**Millstone Nuclear Power Station, Unit No. 2
License Amendment Request - Unreviewed Safety Question
Proposed Revision to Final Safety Analysis Report
Radiological Consequences of Steam Generator Tube Rupture (PLAR 2-00-4)**

License Amendment Request - Unreviewed Safety Question
Proposed Revision to Final Safety Analysis Report
Radiological Consequences of Steam Generator Tube Rupture (PLAR 2-00-4)
Discussion of Changes and Safety Summary

License Amendment Request - Unreviewed Safety Question
Proposed Revision to Final Safety Analysis Report
Radiological Consequences of Steam Generator Tube Rupture (PLAR 2-00-4)
Marked Up Pages

FIGURE 14.6.3-1
STEAM GENERATOR TUBE RUPTURE
RCS TEMPERATURE VS. TIME

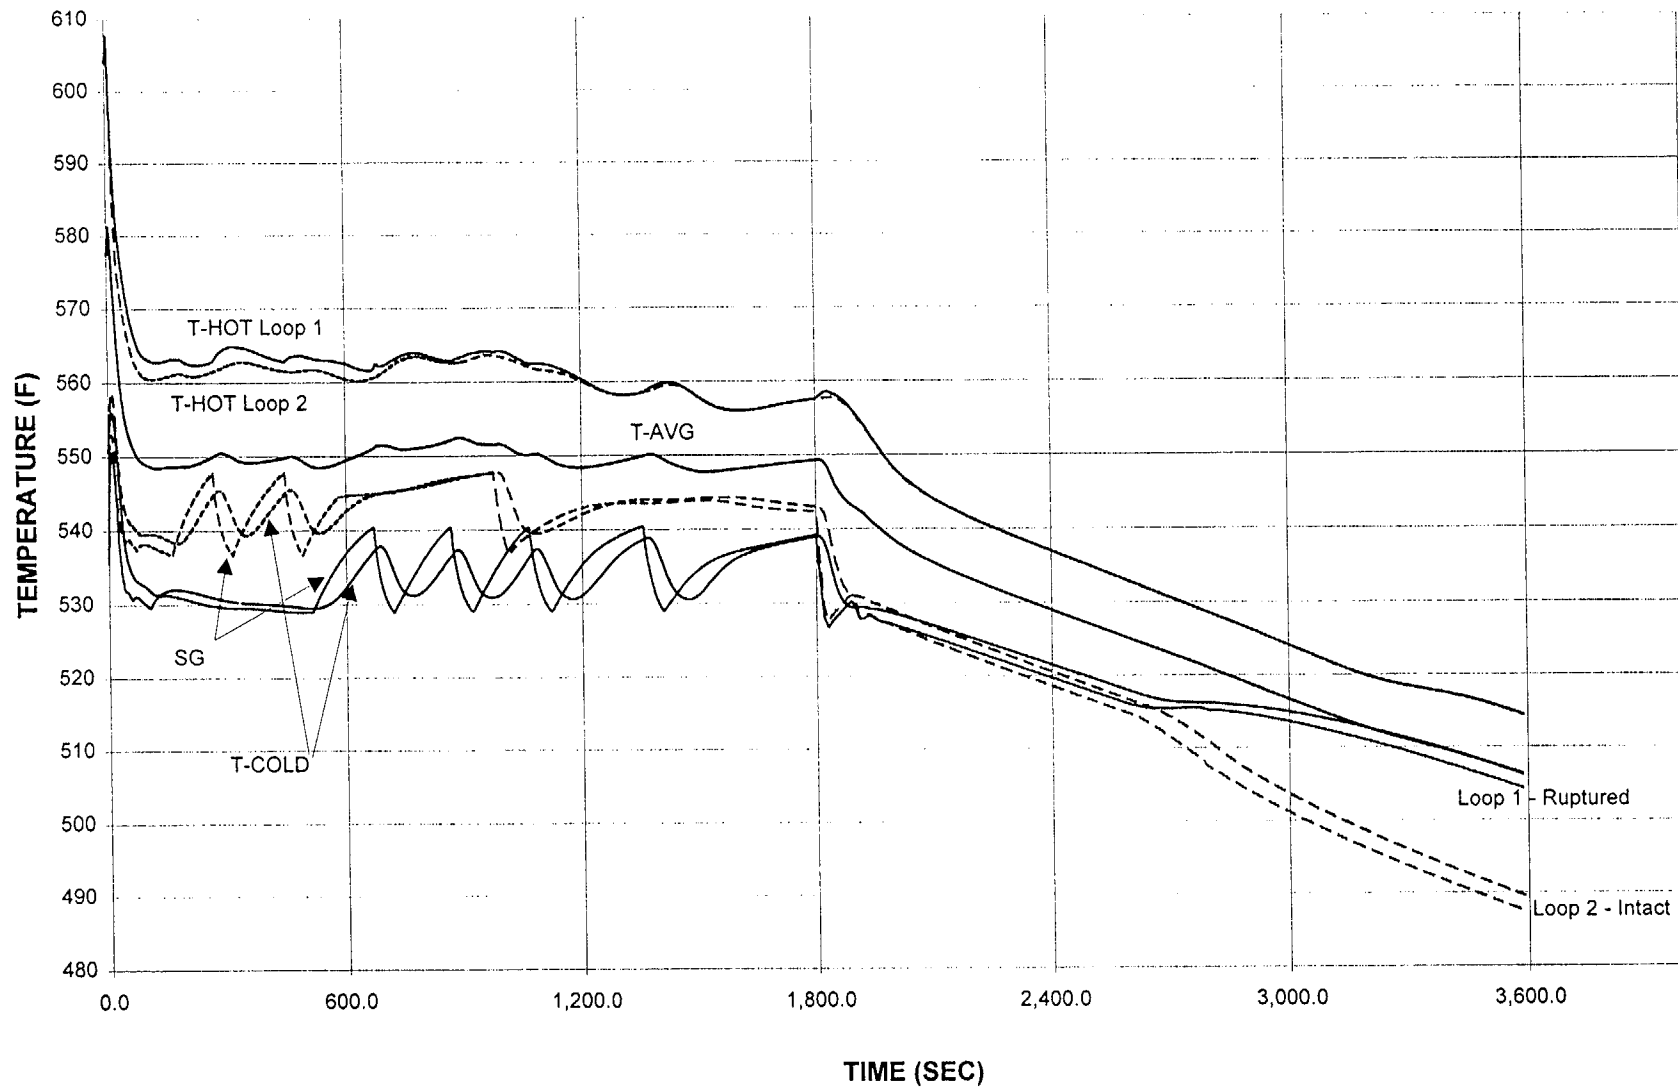
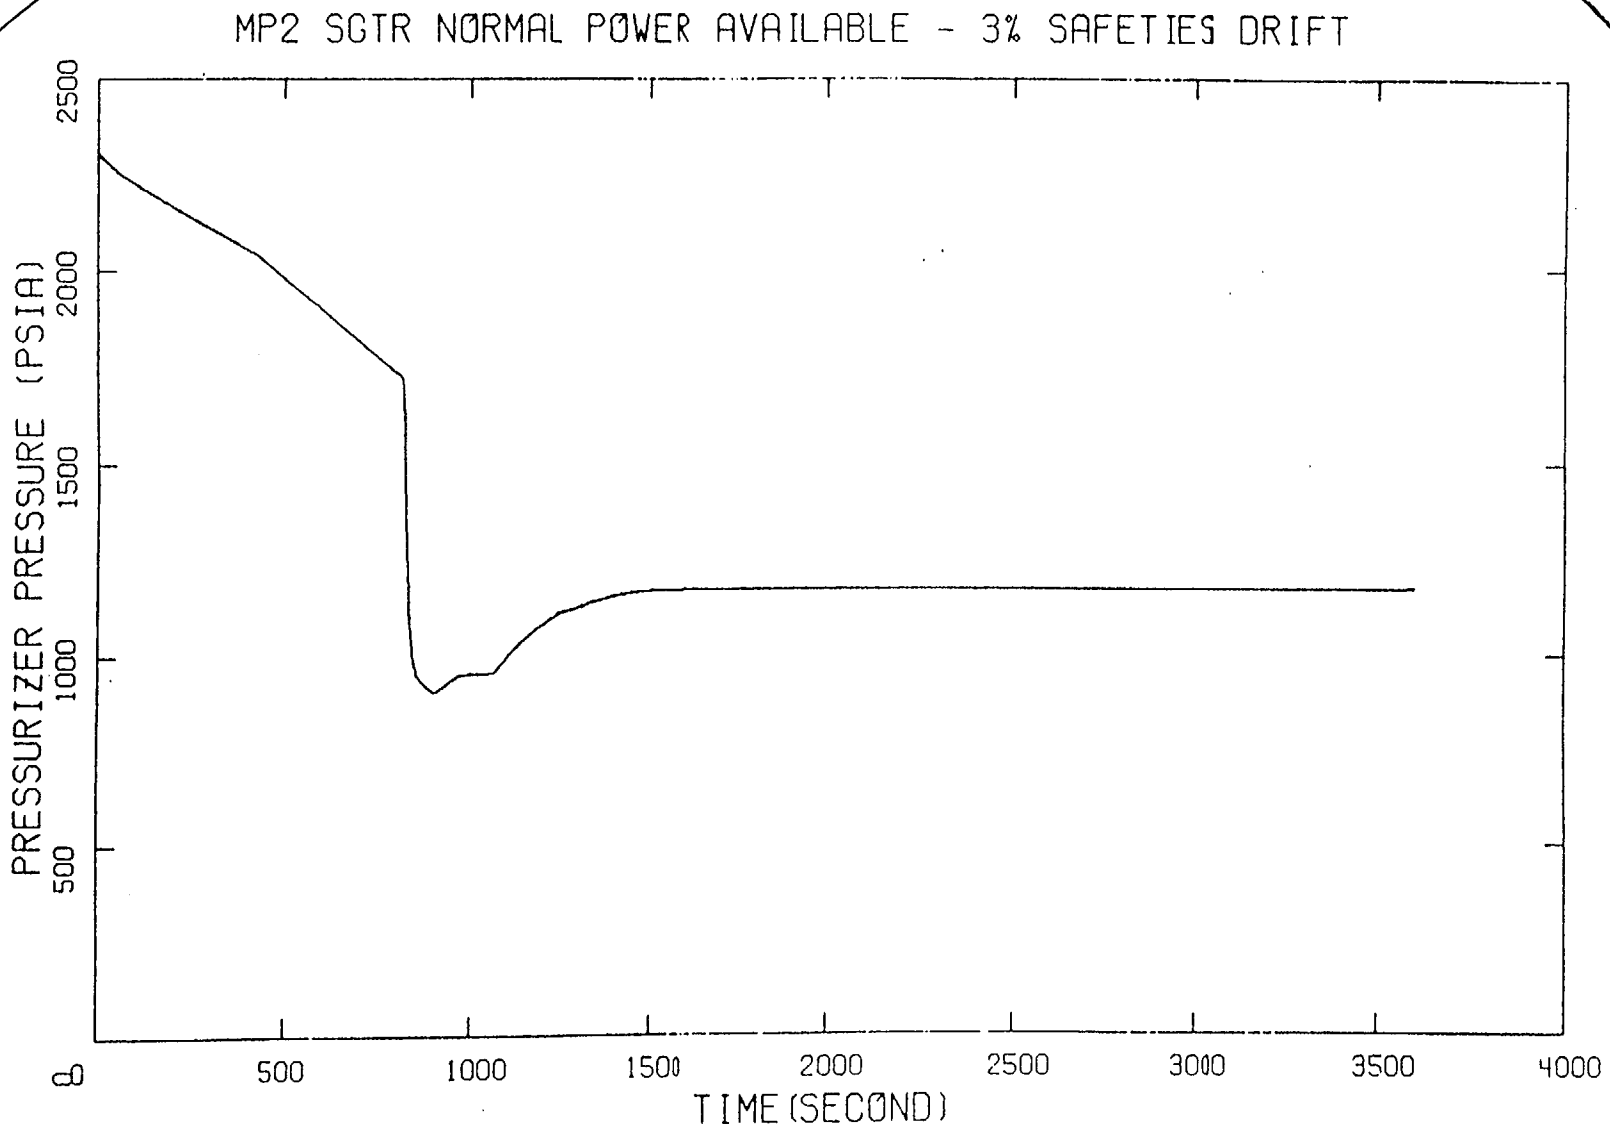
replace with next page

MP2 SGTR WITH LOSS OF OFFSITE POWER

FIGURE 14.6.3-2
STEAM GENERATOR TUBE RUPTURE
PRESSURIZER LEVEL VS. TIME

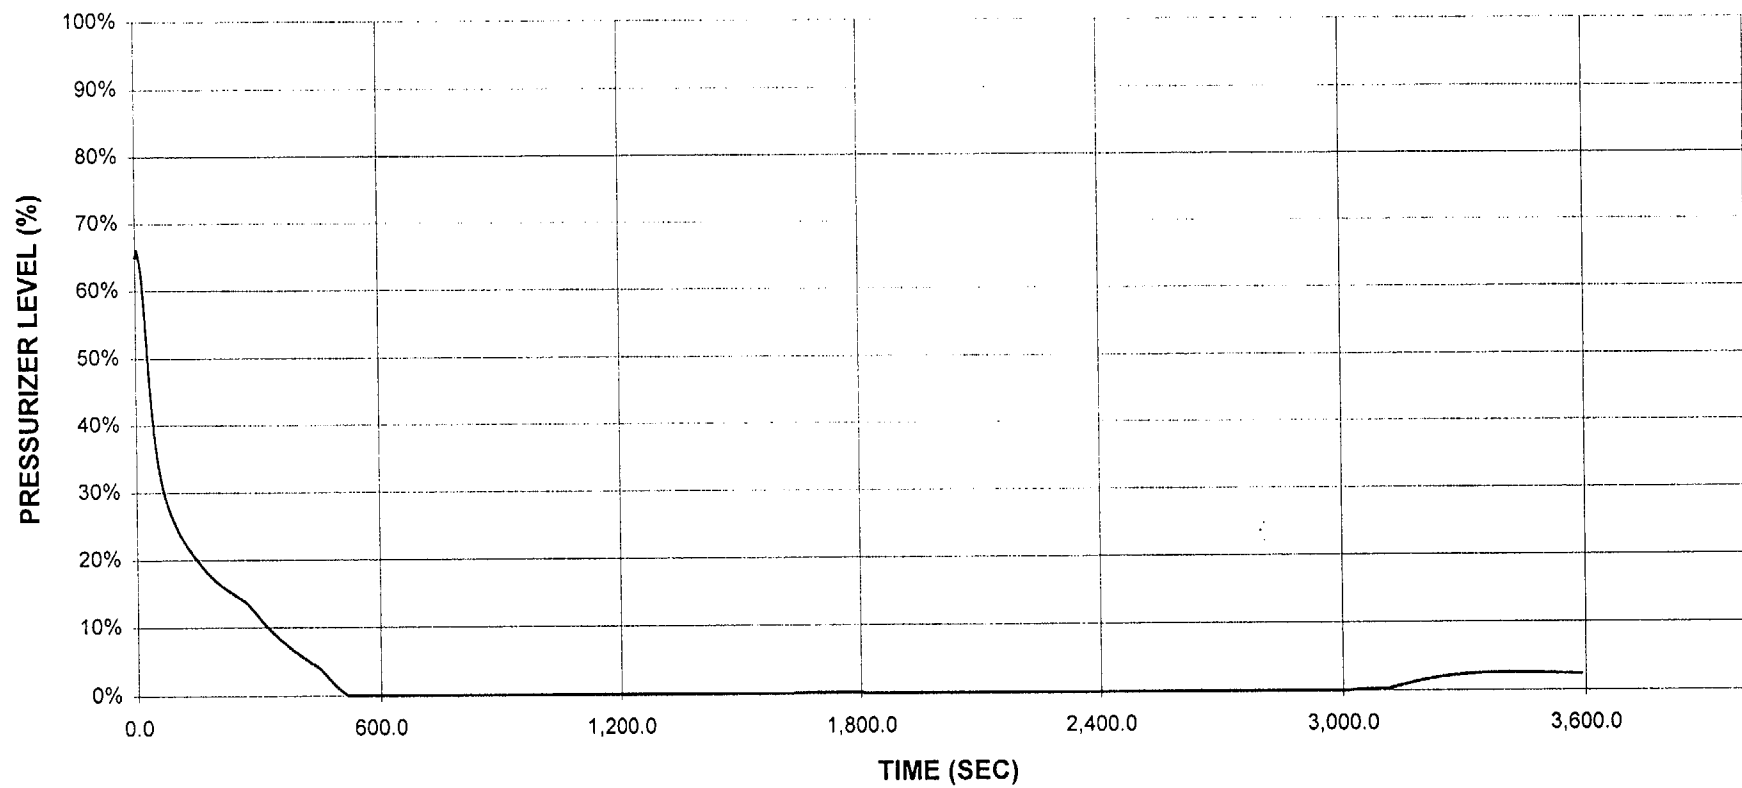
replace with next page

MP2 SGTR WITH LOSS OF OFFSITE POWER

FIGURE 14.6.3-3
STEAM GENERATOR TUBE RUPTURE
PRESSURIZER PRESSURE VS. TIME

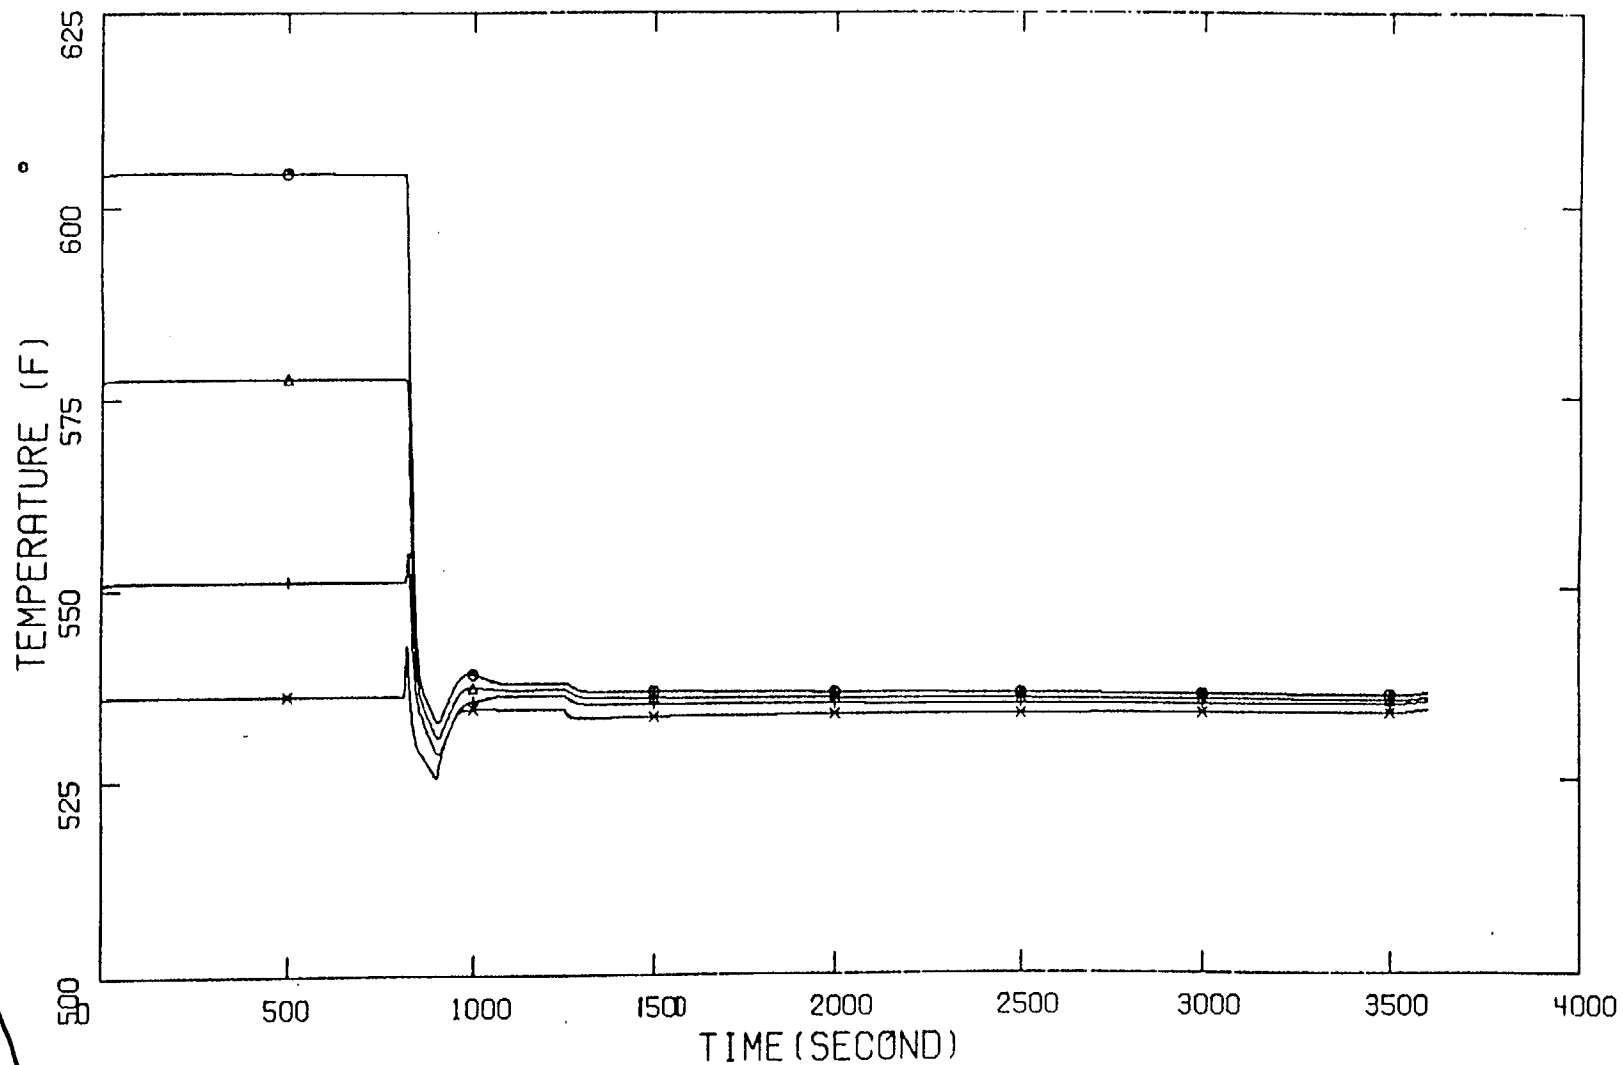
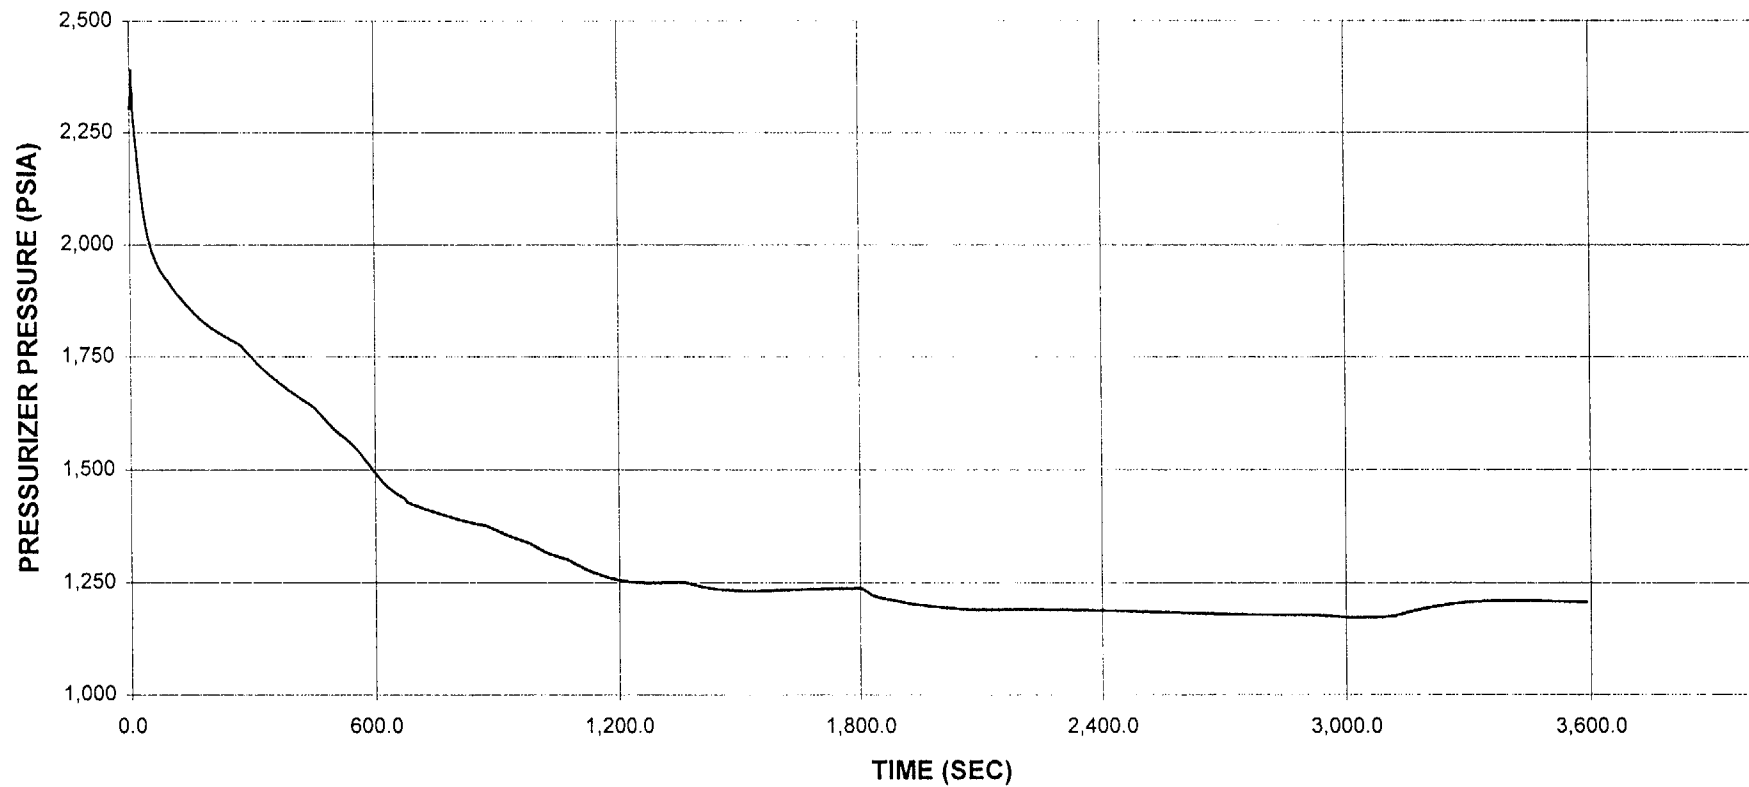
replace with
next page

MP2 SGTR WITH LOSS OF OFFSITE POWER

FIGURE 14.6.3-4
STEAM GENERATOR TUBE RUPTURE
STEAM GENERATOR PRESSURE VS. TIME

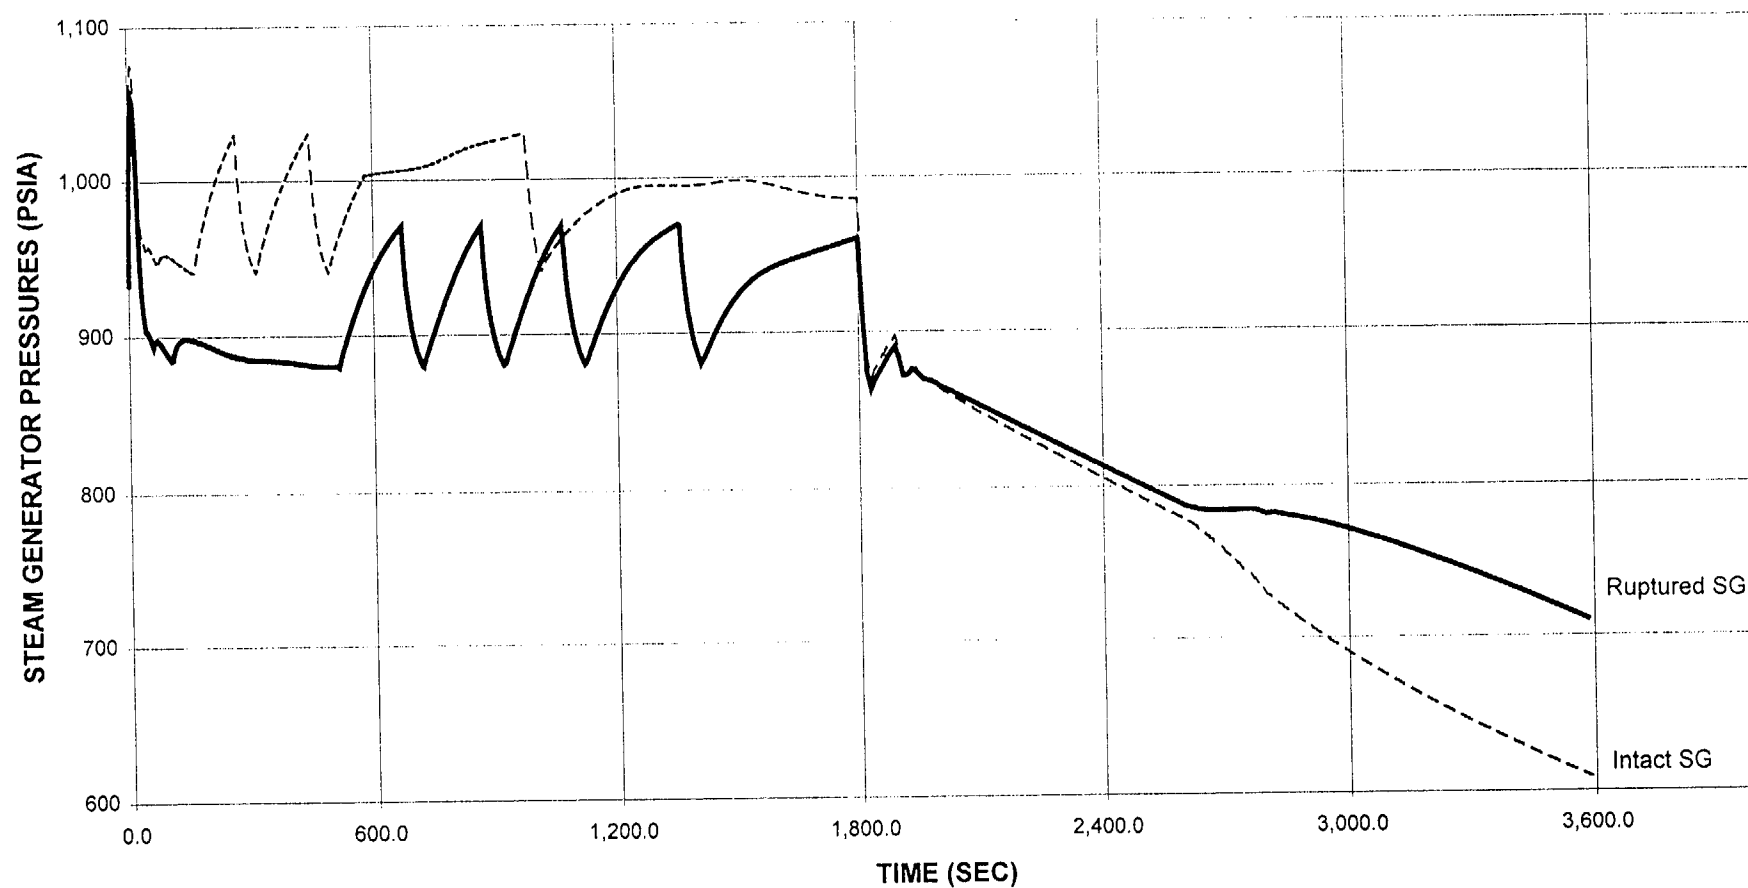
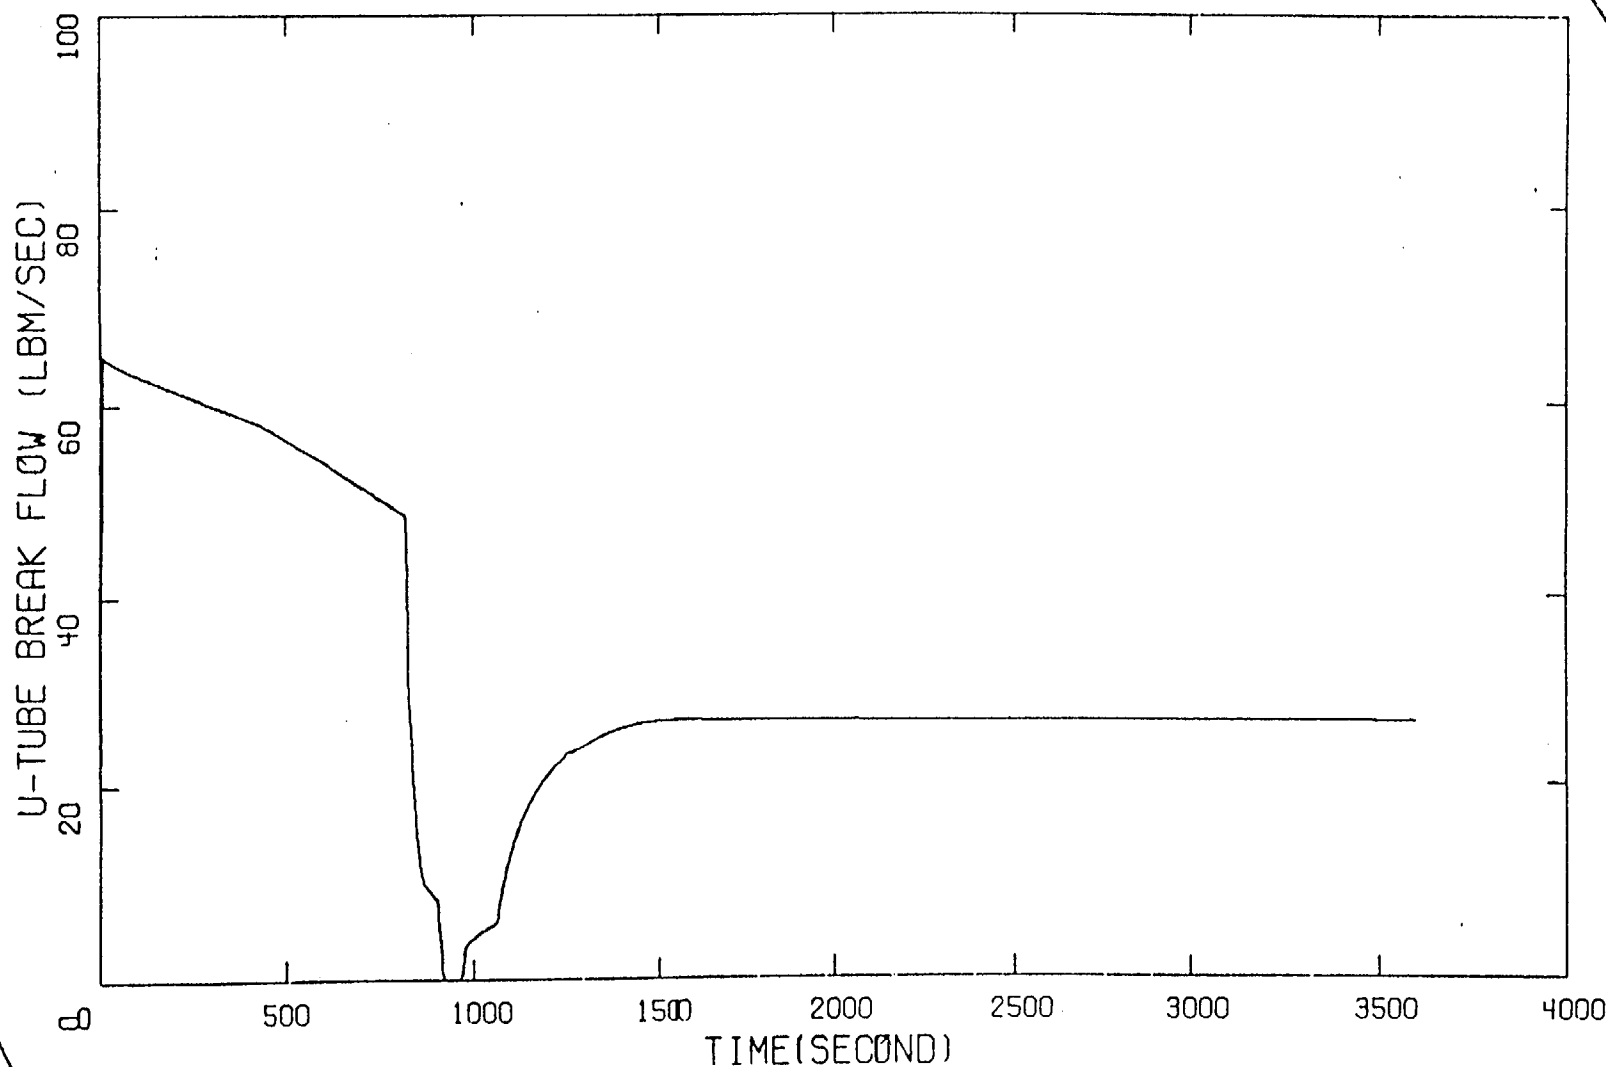
replace
with
next
page

MP2 SGTR WITH LOSS OF OFFSITE POWER
